CONDITIONS OF APPROVAL:

The Fields at Reese Farm - Initial Submittal 11.12.2018.pdf

92. Street Taper

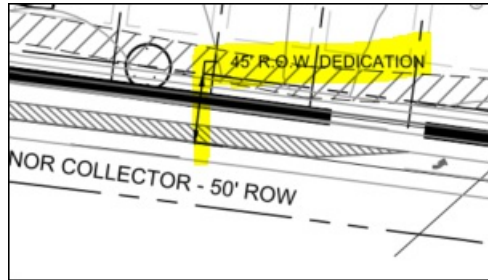
joe.marlo@franklintn.gov *The following is an Advisory Comment and **does not hinder approval of the development plan.***

Advisory Comment: At the Site Plan stage, taper lengths shall be evaluated in greater detail and will be required to conform to the accepted standard in order to ensure public safety and well-being, as well as the continued functionality of the existing and proposed street networks.

**131. Sidewalk Access in Open Space**

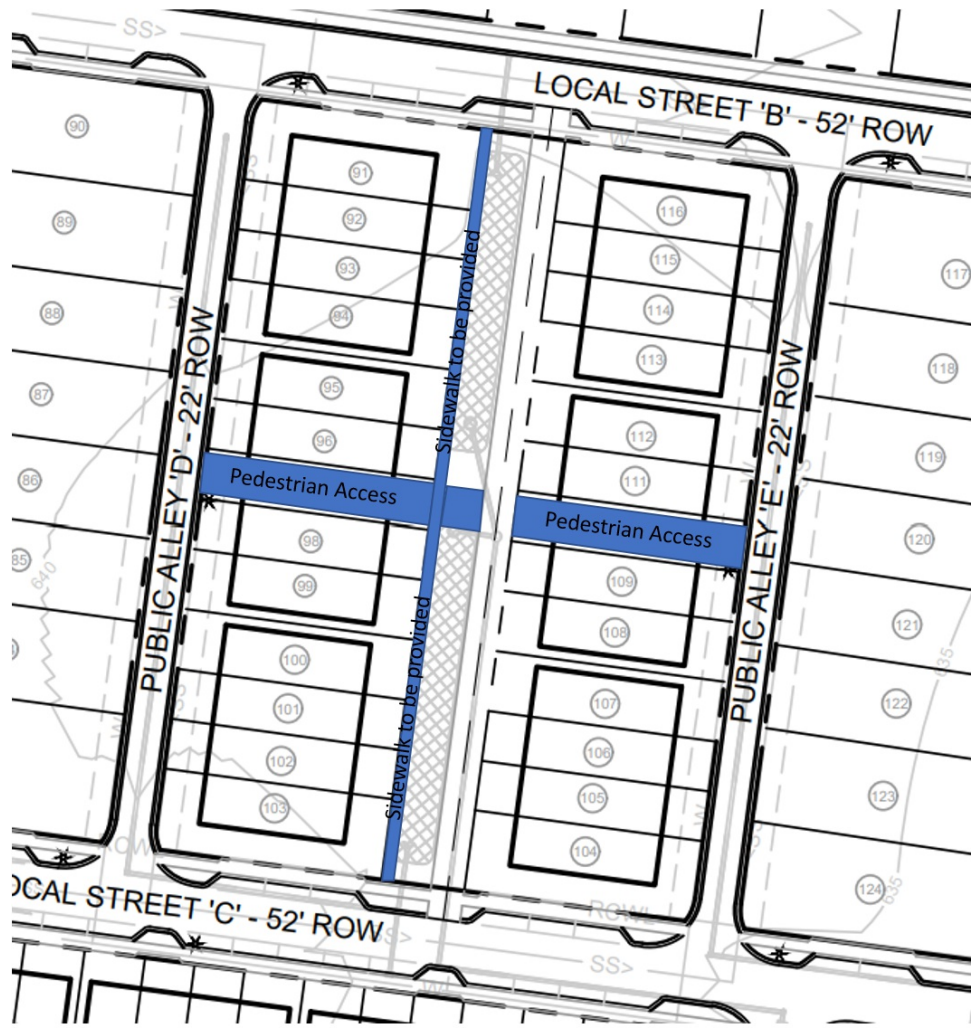
christopher.andrews@franklinton.gov Sidewalks shall be added to both sides of the rectangular open space in the northern portion of the development depicted below, which runs primarily north to south, and where townhouses front from both sides; and that pedestrian access be provided, running generally east to west, in between the proposed row of townhouses. The applicant recognized that as a result of this condition, a reduction in the number of buildable lots may occur.

132. Lot Number for Open Space

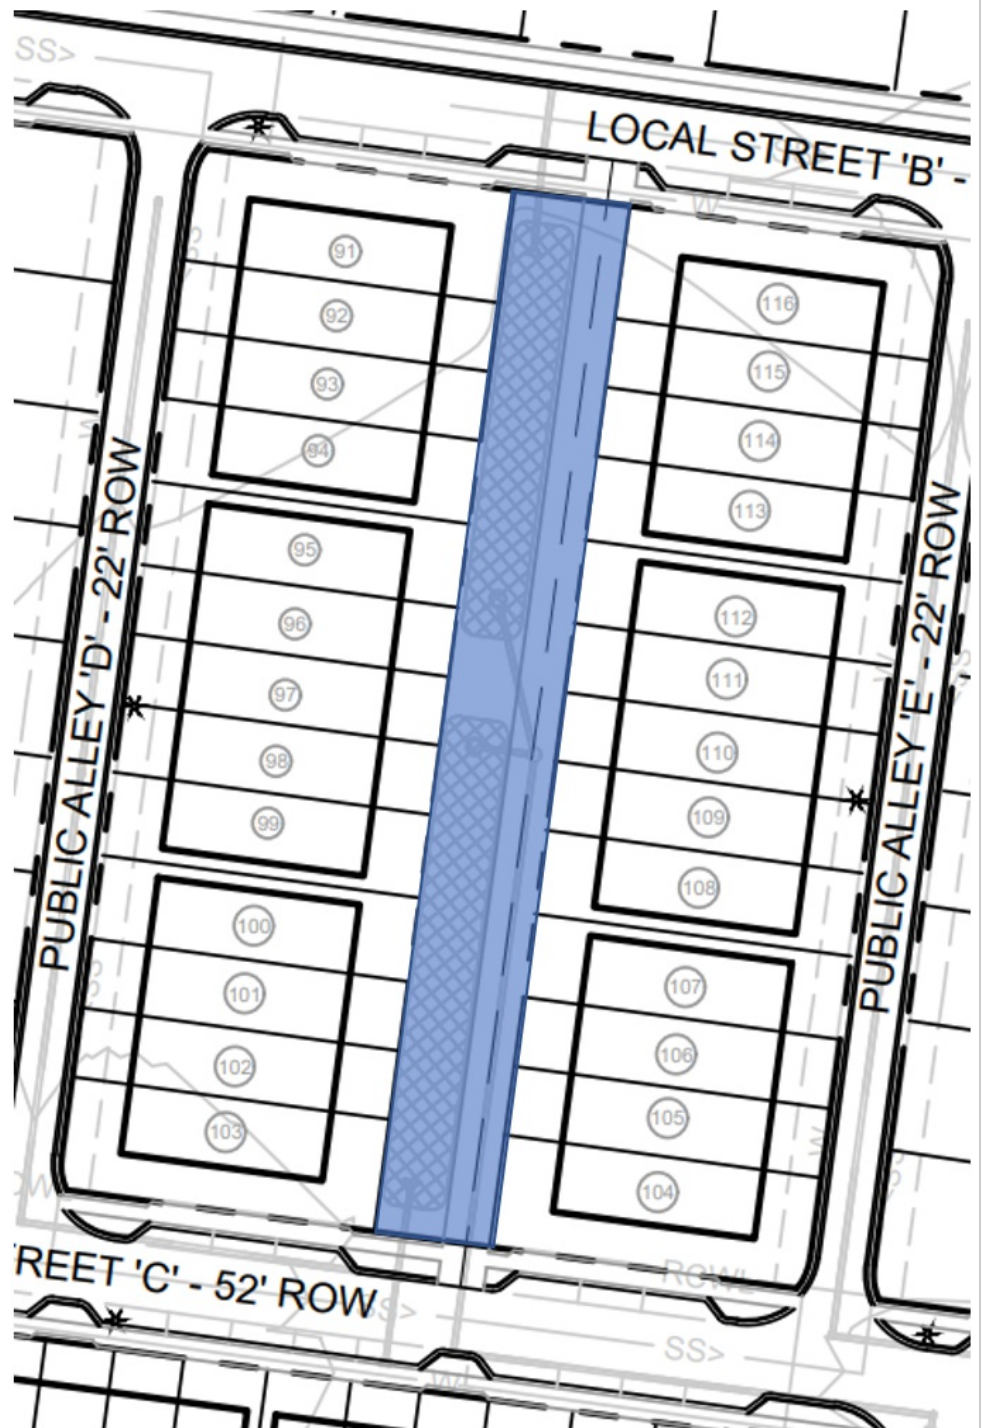
christopher.andrews@franklinton.gov Please provide a lot number for the linear open space shown below:

133. Lots Fronting Open Space / Stream

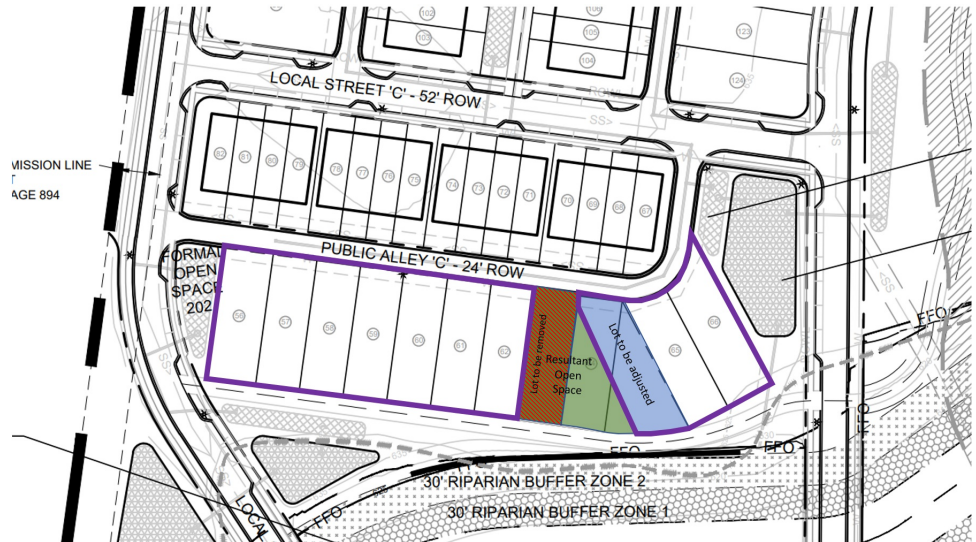
christopher.andrews@franklintn.gov Lots with frontage along the open space containing the stream and that take rear access from proposed "Alley C" as labelled on the development plan shall be modified. Removal of Lot 63 as currently labelled on the development plan, along with the shifting of Lot 64 to be adjacent to Lot 65 helps to satisfy staff concerns related to addressing. Changes to the block layout shall be representative of the depiction below. The applicant recognizes that these changes may lead to the loss of buildable lots.
